Re: Aspire Public School, 1009 66th Avenue, Oakland, California – USEPA November 13, 2009 Approval of Polychlorinated Biphenyls' Cleanup Notification Under Toxic Substances Control Act – New Request for Additional Cap Modification

Re: Aspire Public Schools – Cap Modification and
Modification of USEPA's November 13, 2009 Approval Letter
Date: June 16, 2011

Proposed Toxic Substance Control Act (TSCA) Cap for Pavement Areas –
Former Pacific Electric Motors Facility, 1009 66th Avenue, Oakland, California

PROPOSED PAVEMENT PLAN

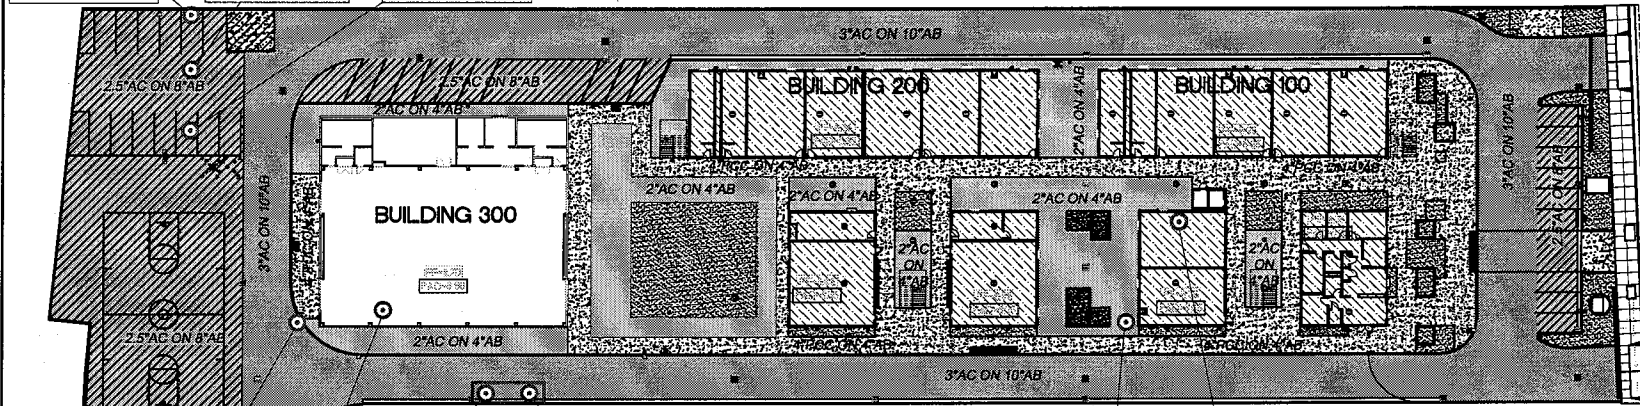
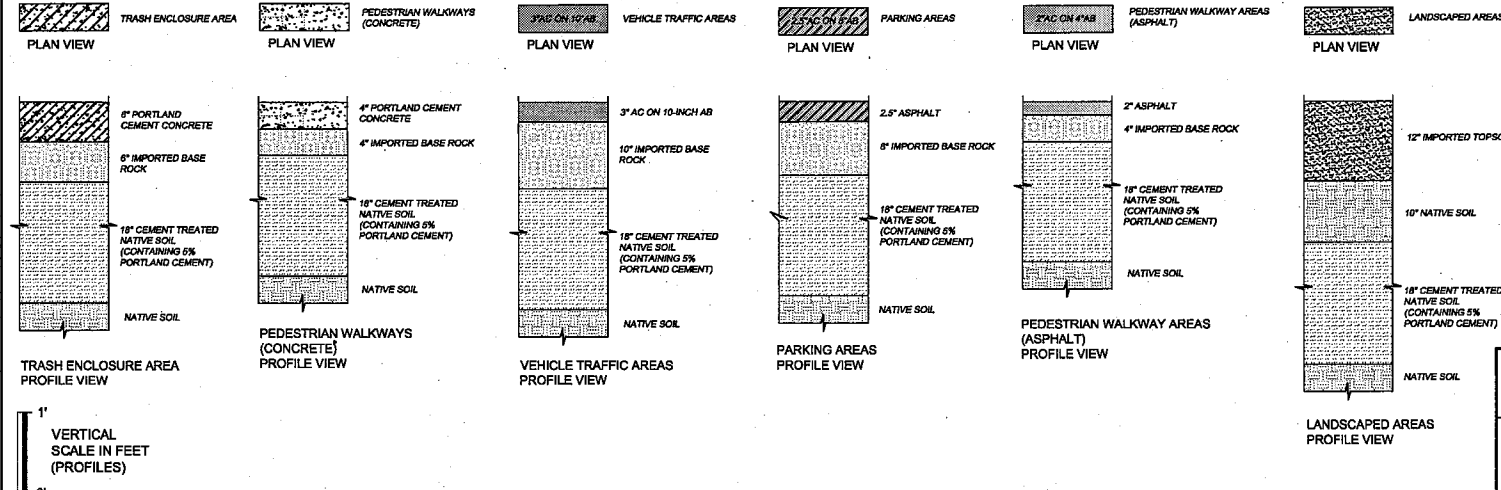
The additional cap modifications proposed in the attached Arcadis' April 25, 2011 letter and described in Figure 2 (Proposed Pavement Plan) of that letter differ from the cap requirements in 40

CFR 761.61(a)(7) and include landscape areas. Figure 2 also describes the soils that will be used to construct the proposed landscape areas; and those areas were not a feature of the original site-wide cap proposed in the October 2009 Notification consistent with the cap requirements in 40 CFR 761.61(a)(7).

- 2. Proposed Landscape Areas.** As described in the attached Arcadis' letter, the proposed landscape areas will consist of an 18-inch layer of cement-treated site soils (bottom layer), a 10-inch soil layer (middle layer) from soils excavated at the site during trenching, and a 12-inch layer (top layer) of imported soils. According to Arcadis, the bottom soil layer contains PCBs at concentrations below the site-specific cleanup level of 0.13 total PCBs as Aroclors. The 10-inch native soil layer proposed to be added above the 18-inch cement-treated soil layer must be replaced with imported soils that have been tested as required in Condition 1 above. This requirement is based on the fact that soils derived from trench excavations at the site that have not been tested for PCBs and other non-PCB contaminants are proposed for use in the 10-inch soil layer for the landscape areas. Edible plants, fruits, and vegetables should not be planted in the proposed landscape areas.

We are approving the proposed design for the site-wide cap (excluding the already approved design for the rat slab areas) and landscape areas described in the attached Arcadis' letter under the TSCA regulations in 40 CFR 761.61(c) (risk-based cleanup option) with the conditions established below. This approval modifies the site-wide cap (excluding the rat slabs) required in Condition 8 of USEPA's November 13, 2009 conditional approval letter.

3. **Notification to Alameda County Department of Environmental Health (ACDEH).** The ACDEH must be notified of the proposed changes to the site-wide cap and inclusion of landscape areas in the cap design given the County's regulatory involvement with the Aspire site.
4. **Modified Site-Wide Cap.** Approval of the modified site-wide cap is only in context to the ability of such cap to prevent human and ecological exposures to PCB levels remaining at the site consistent with the cap requirements in USEPA's November 13, 2009 letter approving the Notification and the TSCA regulations. This approval does not cover structural issues related to the ability of the cap to properly support any estimated load(s) used in developing the cap design.
